**Review of a Special Permit Application and Supporting
(Risk Analysis) Document**

**Energy Transportation Solutions, LLC
8350 NW 52nd Terrace, Suite 300, Doral, FL 33166**

Phani K. Raj

March 15, 2018

Figure E2. FN curve of the aggregate SR for the mainline train movement of LNG DOT-113s for the low speed case (up to 25 mph) and high speed case (greater than 25 mph and up to 50 mph) along the 227 mile long example mainline route.

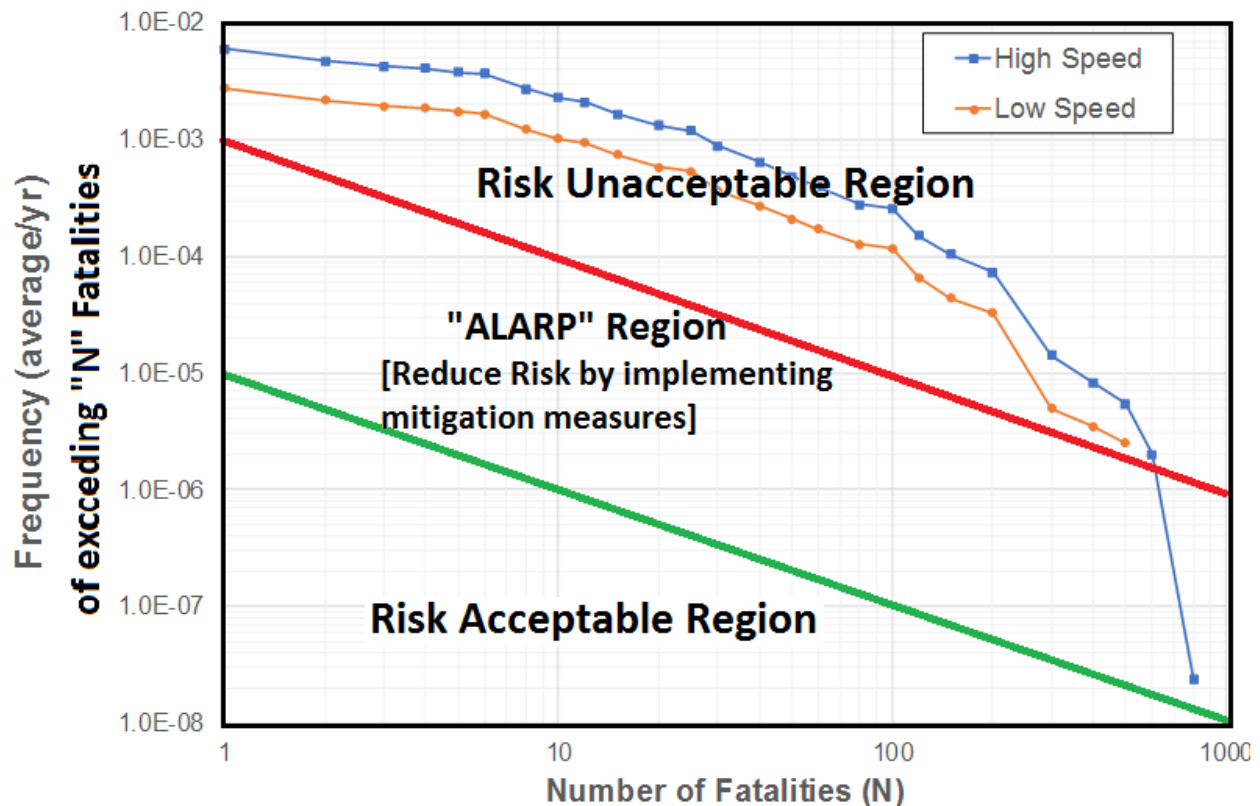
- 11 The aggregate Societal Risk presented in the report for both low speed and higher speed operations are significantly above the acceptable range, per the NFPA 59A criteria.

The following figure from the risk analysis report illustrates the results (shown with dot-connected lines). In the same figure two lines from the NFPA 59A standard on societal risk acceptability are shown. The red line illustrates the upper bound of risk acceptability. The green line indicates the lower bound, below which the risk is acceptable without review. The region in between is

As can be seen the aggregate societal risk values for the example route (of 227 miles) chosen for evaluation indicate that in both high speed (> 25 mph and less than 50 mph) and low speed (< 25 mph) the risks are well above the red line – the limit of risk acceptability, over most of the population exposure (fatality) values. From just this criterion alone, the risks are too high and are not acceptable. It is not known what the societal risks are for real routes proposed by ETS.
